Label Marking Design

Not Finalized Strategy

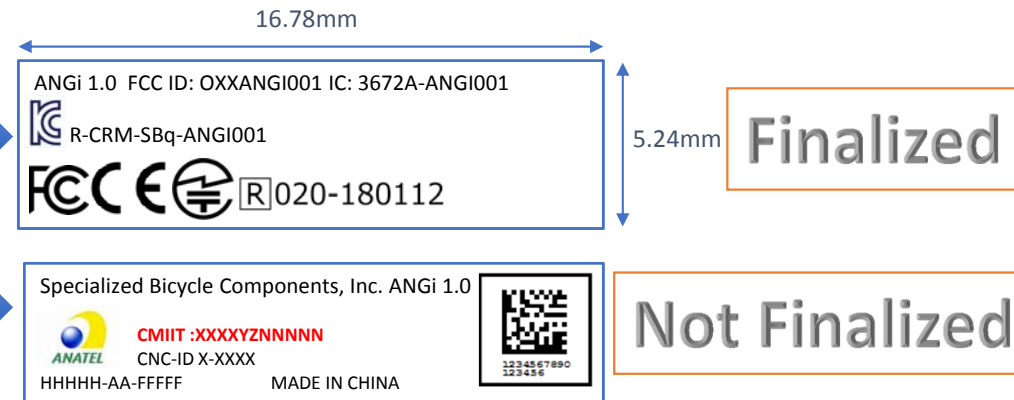
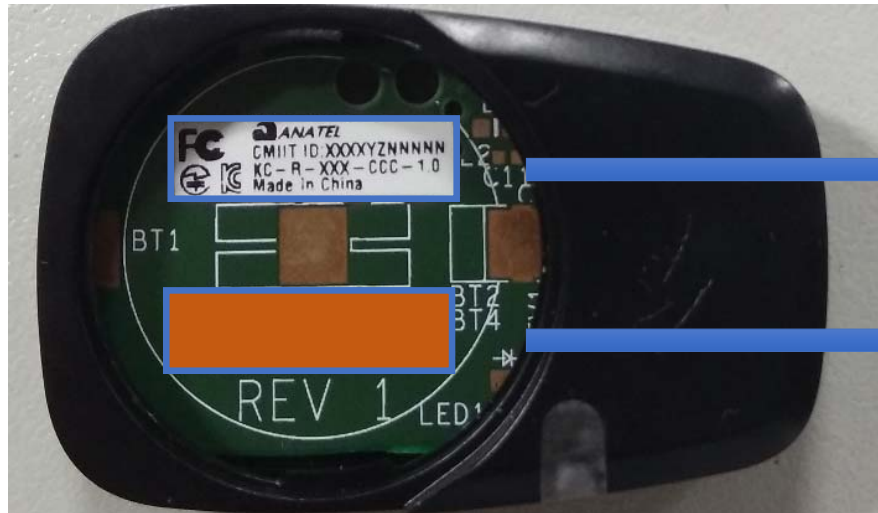
- If Anatel & Brazil ID does not come on time – we will completely skip this label when we start production.
- If that happens the serial 2D label will be a stand alone label & Made in China has to be moved to the first label.

- For Anatel (Brazil). They are requesting adding the following RF Statement: “Este equipamento não tem direito à proteção contra interferência prejudicial e não pode causar interferência em sistemas devidamente autorizados”. There is no room on the label for this. **Potential issue, no room available.**

- For Korea. NTS’s advisors still saying we can’t put the Korea Logo and registration number in the battery compartment. Must be on exterior of product. **Potential issue, no surface available for external label.**

- Argentina requesting the CNC ID # (CNC-ID X-XXXX) appear on the product label. Will it fit? - **Added**
- Japan now wants the R square and certification ID on the product as well as the Giteki Logo. - **Added**

- China wants applicant on product label. Applicant is “Specialized Bicycle Components, Inc.” - **Added**
- Paraguay wants Conatel Logo and Registration Number on product label. Per the label description attached in Pam’s email, height just for the logo is 6mm. Too big for our product label. **Potential issue**

- Further Conatel wants Name of Manufacturer (Flex), and Brand and Model number (we already have this on the label) on the label. If we can convince Conatel the logo and Registration number can only go on the manual and packaging, the only addition to the label would be the manufacturer (Flex). Based dimension requirement 6mm x 4mm – **too big to fit the label space.**
